dsPIC33CH512MP508 Family Silicon Errata and Data Sheet Clarification

The dsPIC33CH512MP508 family devices that you have received conform functionally to the current Device Data Sheet (DS70005371D), except for the anomalies described in this document.

The following typographic corrections and clarifications are to be noted for the latest version of the device data sheet (DS70005371D):

FIGURE 1-1: I/O RAMP

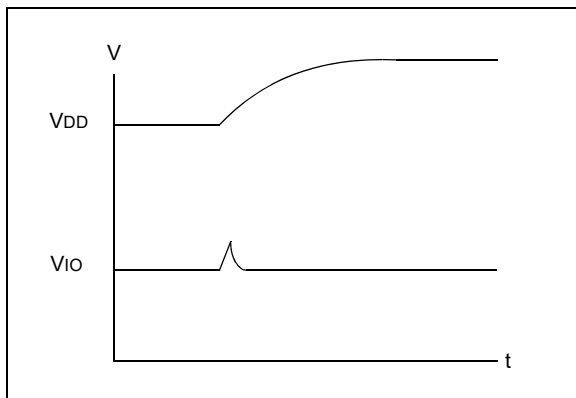
During a fast device power-up, when the VDD ramp is less than 4 mS, the I/O pins may drive up to 100 μ A current for a duration of up to 10 μ S (Figure 1-1).

1. Slow down the VDD ramp time (greater than 4 mS for VDD to ramp 0V to 3.3V).
2. Ensure the circuitry that is connected to the pins can endure this pulse.

Example applications affected may include complementary power switches, where a transient current shoot-through might occur. High-voltage applications with complementary switches should power the high-voltage 200 μ Sec later than powering the dsPIC[®] device to avoid the current shoot-through. This behavior is specific to each device and not affected by aging.

FIGURE 2-2: SUGGESTED PLACEMENT OF THE OSCILLATOR CIRCUIT

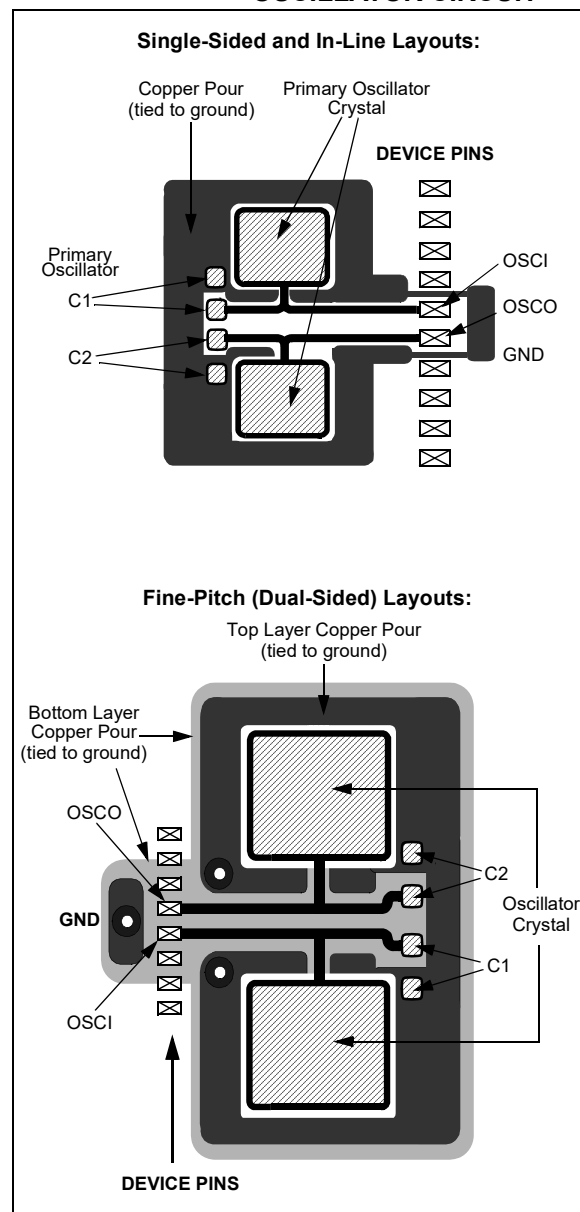
Additional information is added to [Section 2.5 “External Oscillator Pins”](#) and [Section 2.6 “External Oscillator Layout Guidance”](#) is added.

Use best practices during PCB layout to ensure robust start-up and operation. The oscillator circuit should be placed on the same side of the board as the device. Also, place the oscillator circuit close to the respective oscillator pins, not exceeding one-half inch (12 mm) distance between them. The load capacitors should be placed next to the oscillator itself, on the same side of the board. Use a grounded copper pour around the oscillator circuit to isolate it from surrounding circuits. The grounded copper pour should be routed directly to the MCU ground. Do not run any signal traces or power traces inside the ground pour. If using a two-sided board, avoid any traces on the other side of the board where the crystal is placed. Suggested layouts are shown in [Figure 2-2](#). With fine-pitch packages, it is not always possible to completely surround the pins and components. A suit-

able solution is to tie the broken guard sections to a mirrored ground layer. In all cases, the guard trace(s) must be returned to ground.

FIGURE: ADC ANALOG INPUT MODEL

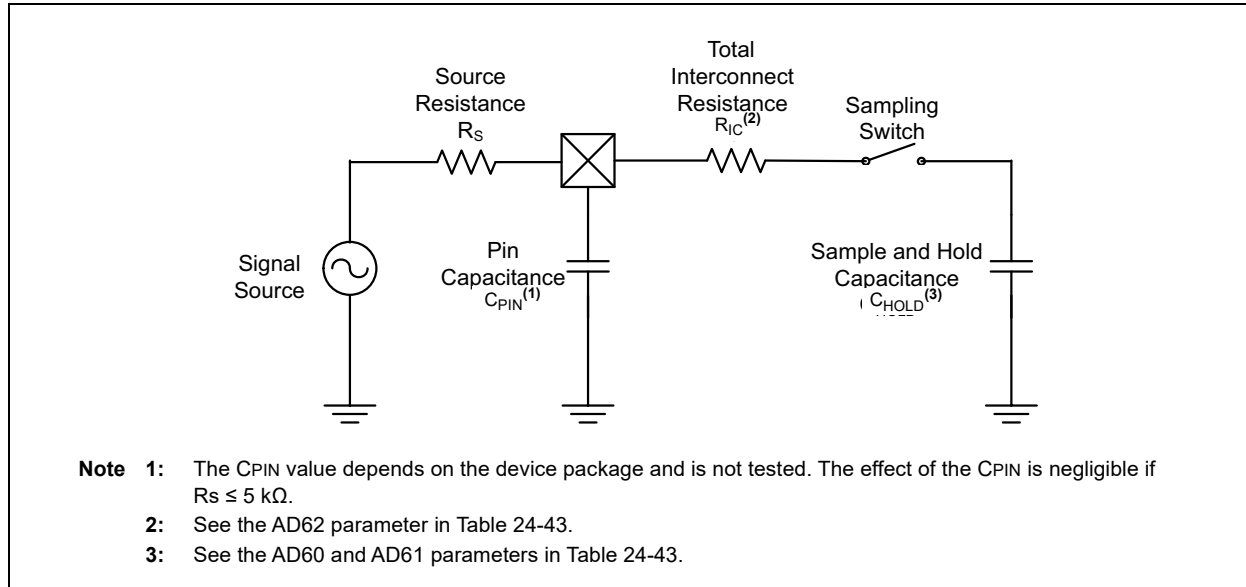
The following [Sampling Time Requirements](#) section has been added to both [Section 3.16 “High-Speed, 12-Bit Analog-to-Digital Converter \(Main Core ADC\)”](#) and [Section 4.7 “High-Speed, 12-Bit Analog-to-Digital Converter \(Secondary Core ADC\)”](#).

The total acquisition time for the Analog-to-Digital conversion is a function of the Holding Capacitor (C_{HOLD}) charge time. For the ADC module to meet its specified accuracy, the Holding Capacitor (C_{HOLD}) must be allowed to fully charge to the voltage level on the analog input pin. The Signal Source Impedance (R_S) and the Interconnect Impedance (R_{IC}) combine to affect the time required to charge the C_{HOLD} . The total resistance ($R_S + R_{IC}$) must therefore, be small enough to fully charge the Holding Capacitor within the selected sample time.

FIGURE 21-4: FLASH SECURITY SEGMENTS (SINGLE PARTITION MODE)

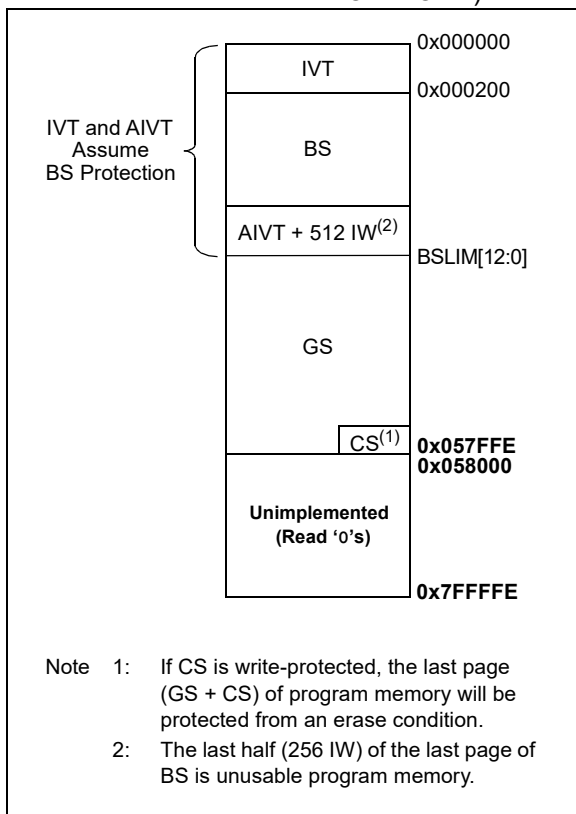
Figure 21-4 has been updated as shown in **bold** below.

FIGURE 21-5: FLASH SECURITY SEGMENTS (DUAL PARTITION MODE)

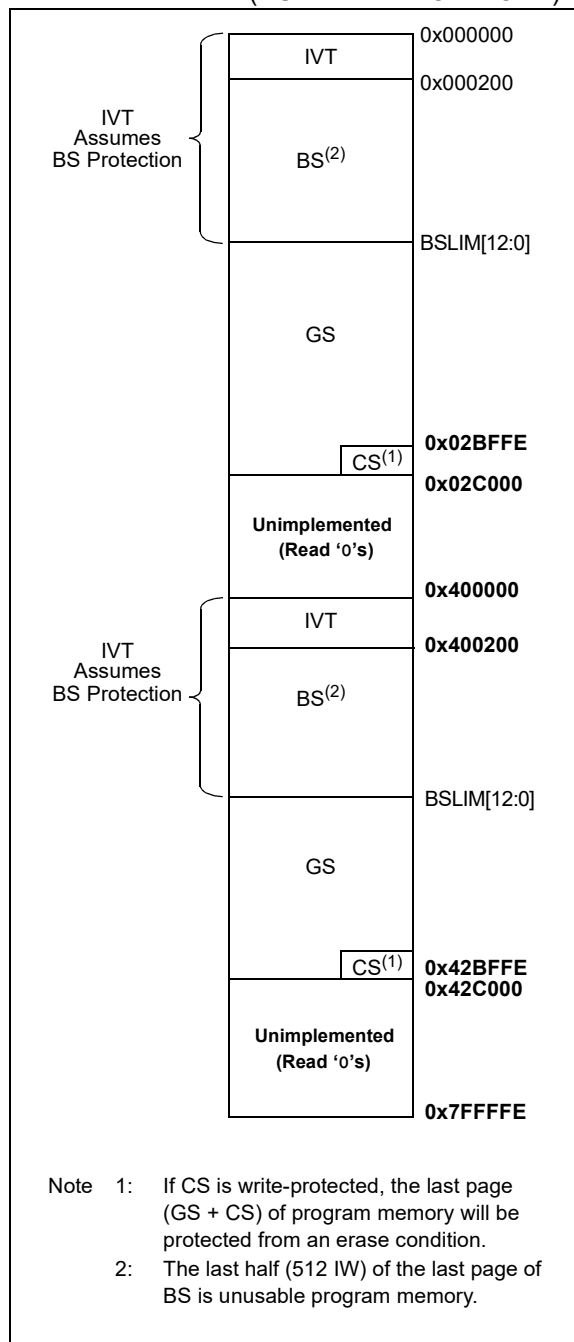
Figure 21-5 has been updated as shown in **bold** below.

FIGURE 4-3: PRAM (PROGRAM MEMORY) FOR SECONDARY CORE dsPIC33CH512MP508S1 DEVICES

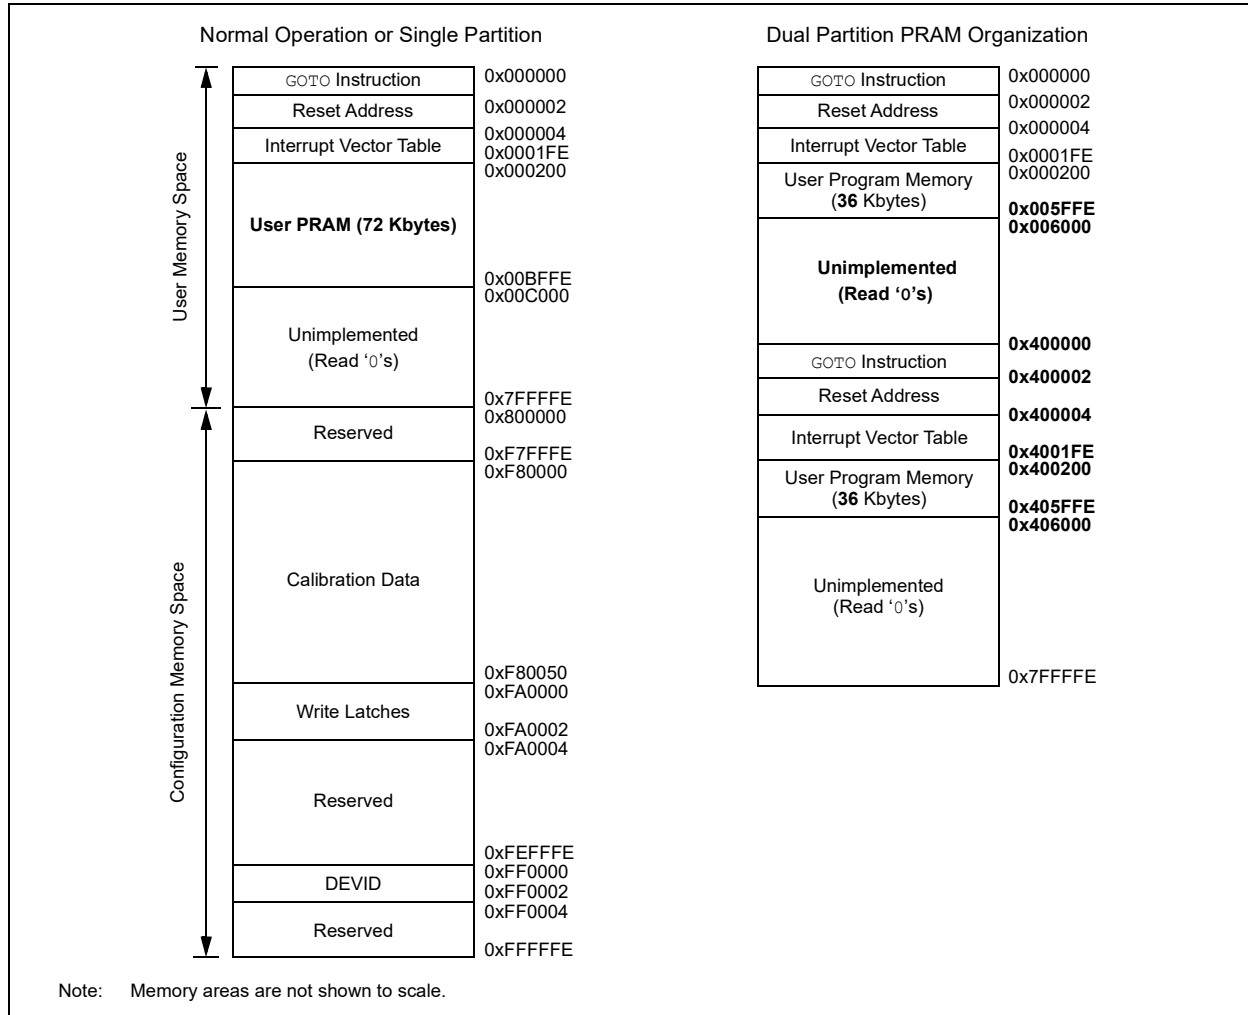
Figure 4-3 has been updated as shown in **bold** below.
